NUCLEAR REGULATORY COMMISSION

ADVISORY COMMITTEE ON REACTOR SAFEGUARDS

SUBCOMMITTEE MEETING

FLUID DYNAMICS

Figure 1 : Impact force transient for addition to the empirical data for Types 1 to 3 deflectors.

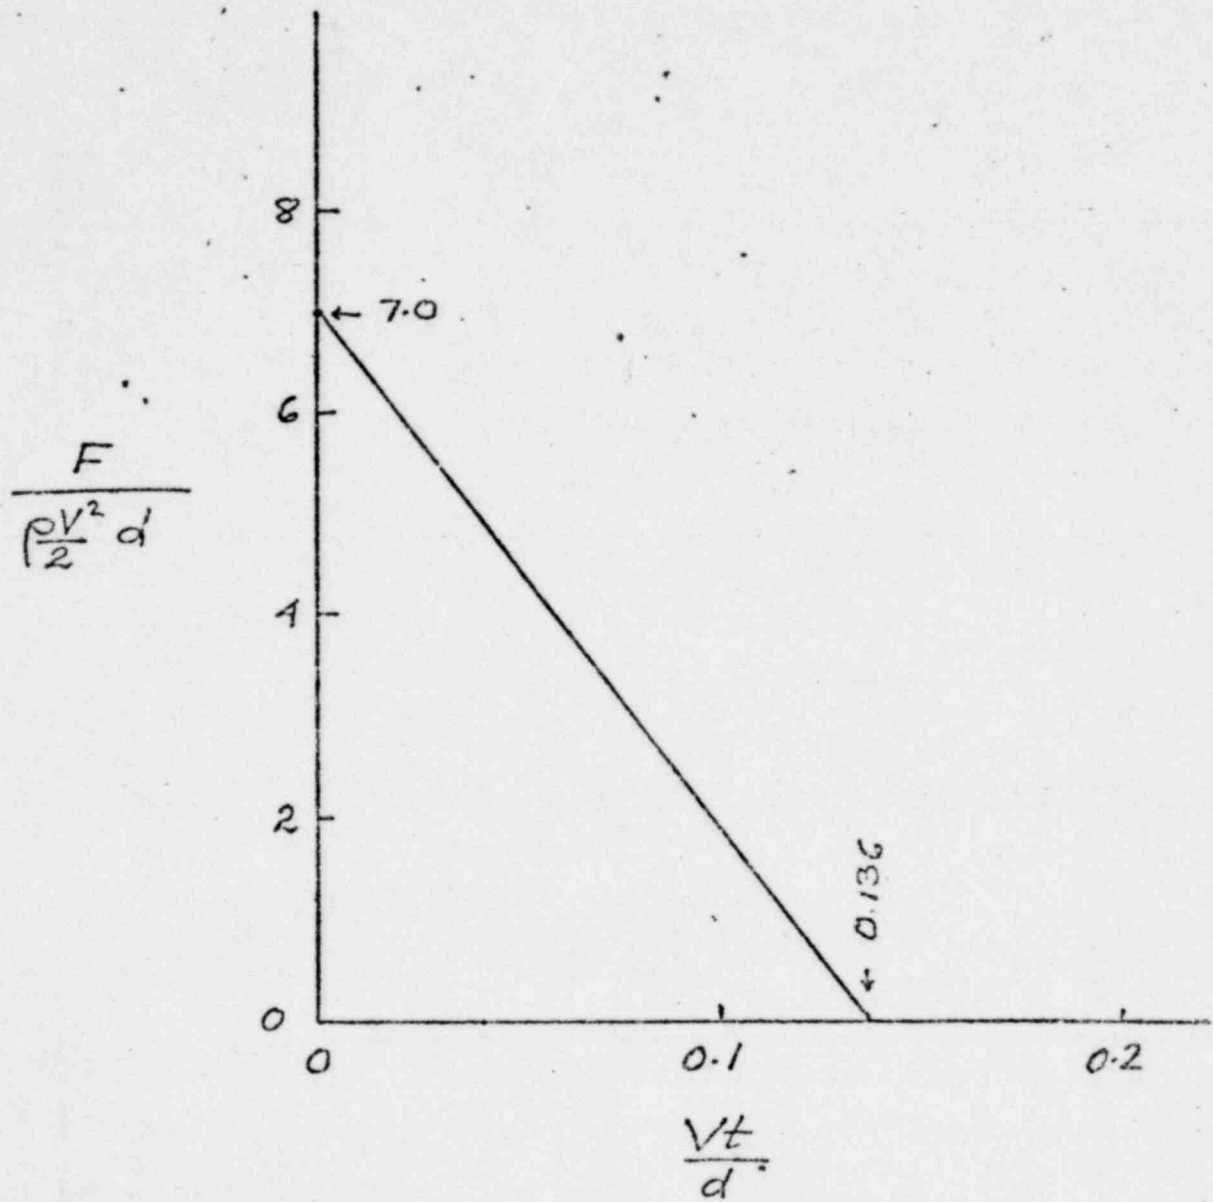
NRC : OK IF

1. ADD EMPIRICAL IMPACT SPIKE FOR CYLINDERS
(FROM SRI/EPRI DATA)
2. INTERPRET 3D POOL SWELL EFFECTS CONSERVATIVELY,
AS REQUIRED BY NRC.
3. WHEN LOAD IS APPLIED IN A DYNAMIC CALCULATION
FOR A MARK I DEFLECTOR, THE INERTIA DUE
TO THE ADDED MASS OF THE WATER SHOULD
BE ACCOUNTED FOR ($M_H = I/VW$)

IMPACT TRANSIENT / STEADY DRAG FOR CYLINDER

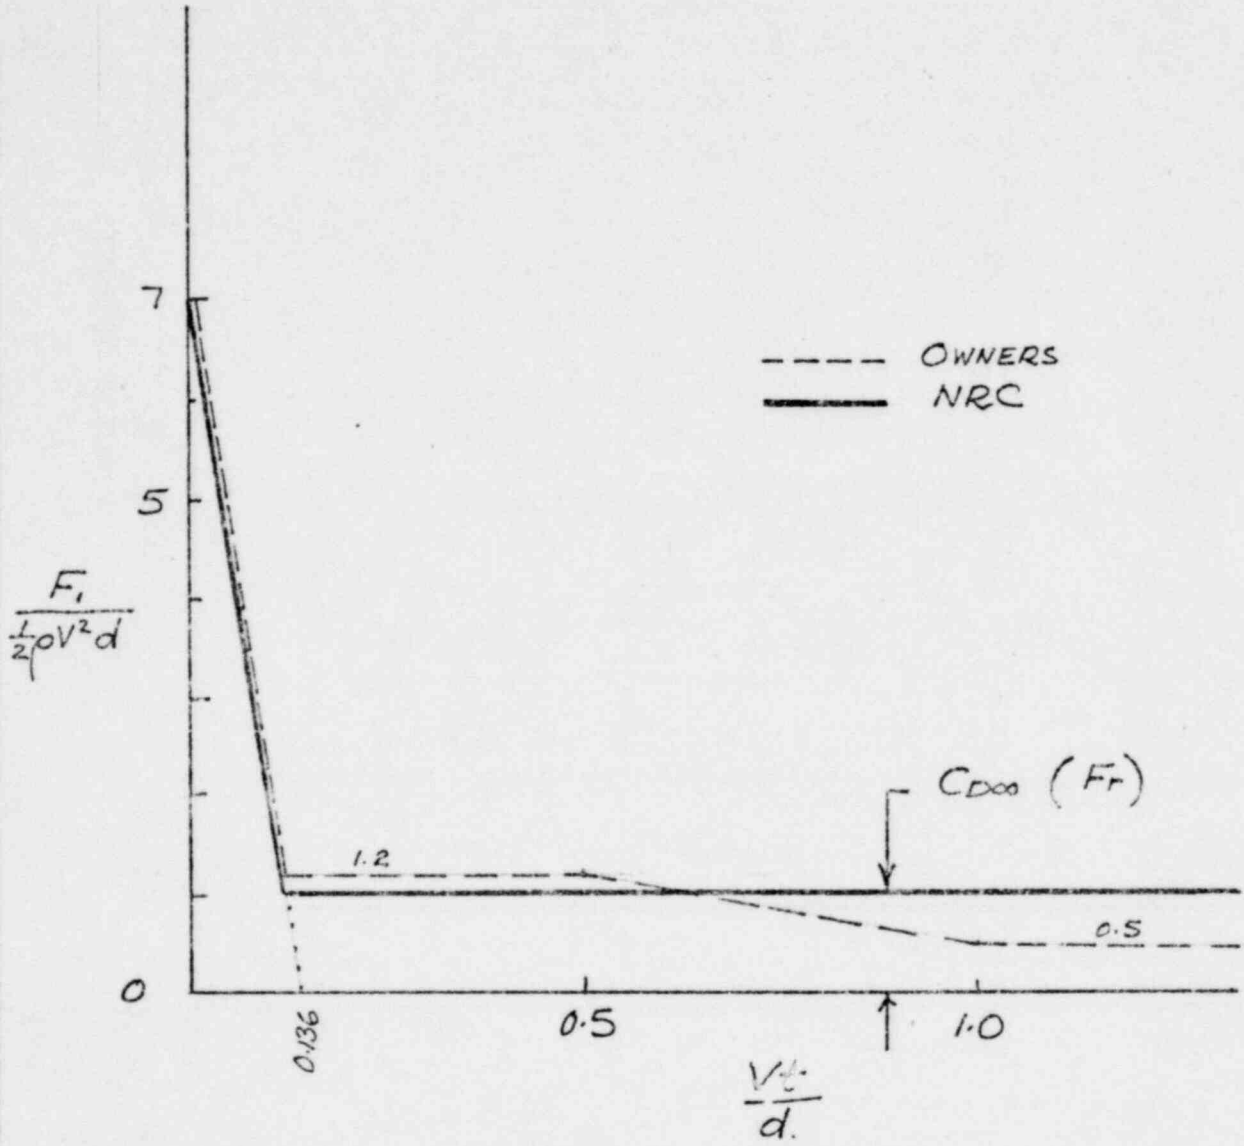
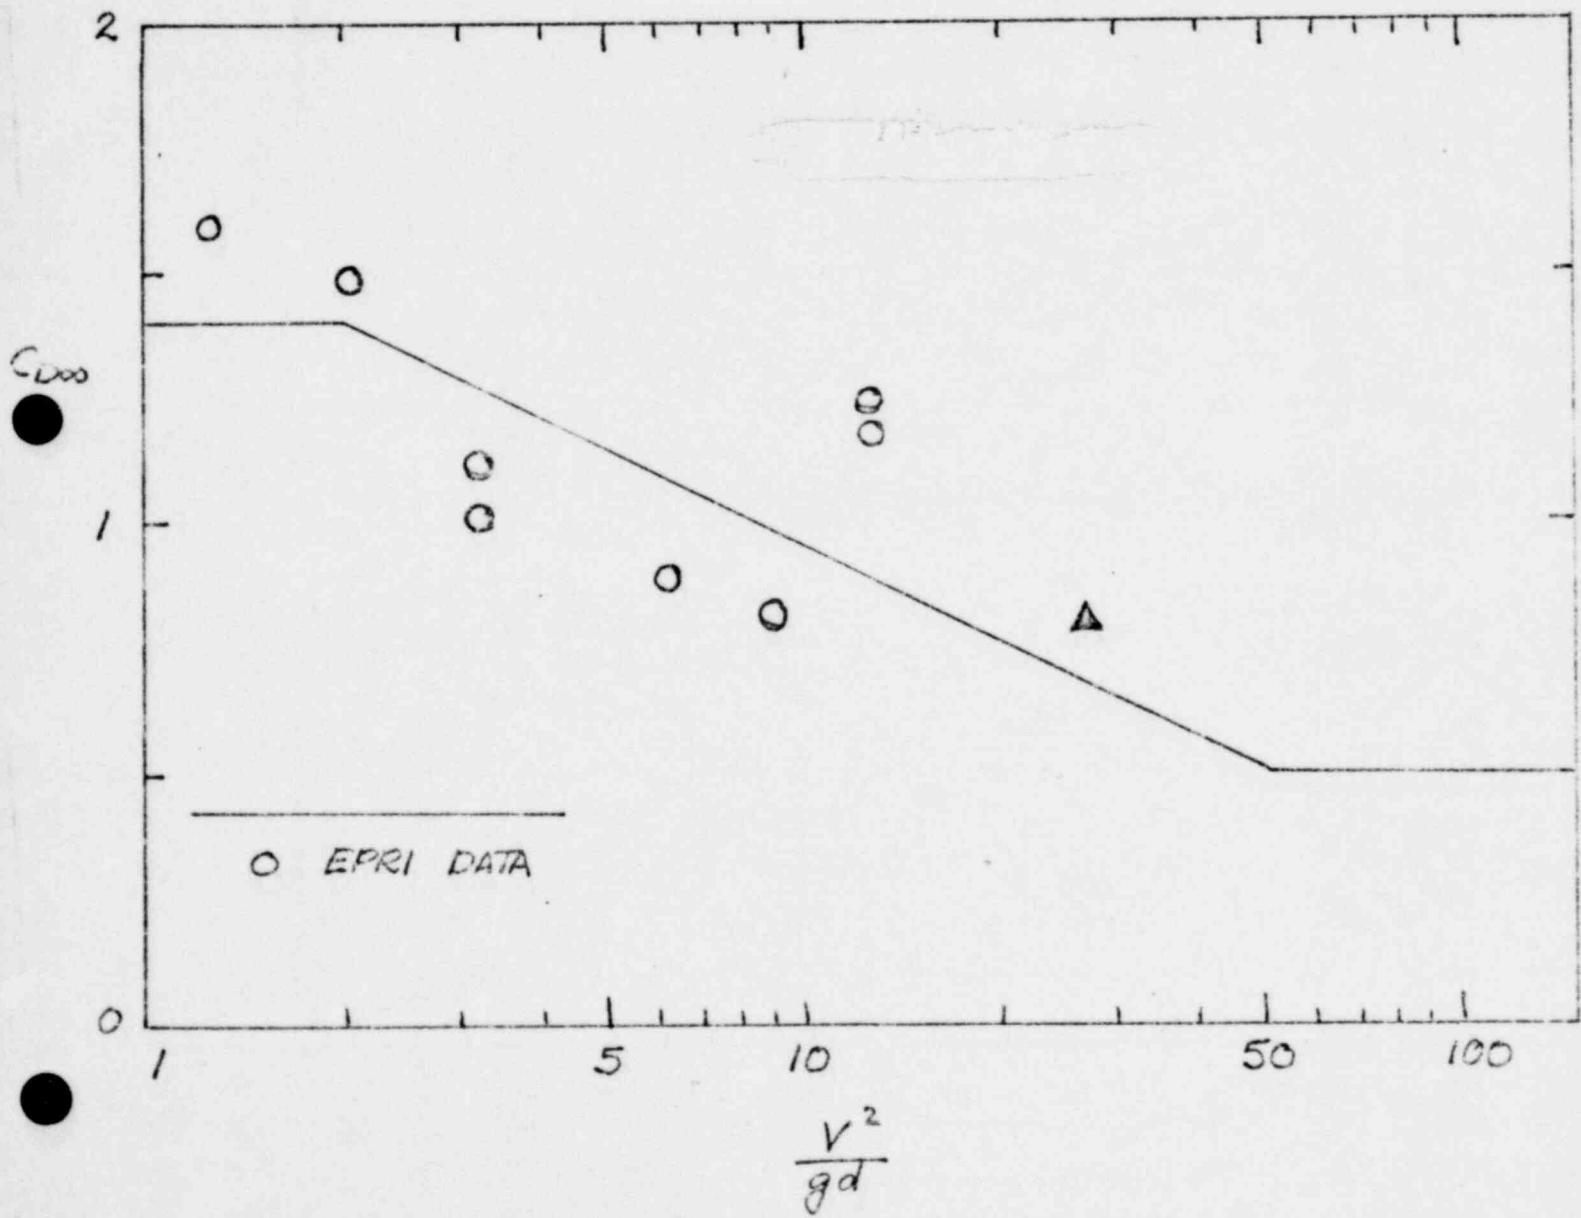
Finds the general methodology acceptable, but differs from the owners in its application of step (2a). ∴ the owners have a nonconservative steady drag for cylinders, and have not accounted properly for the impact transient on wedges.

In addition, NRC requires that when the load is applied, the added mass of the water must be accounted for.
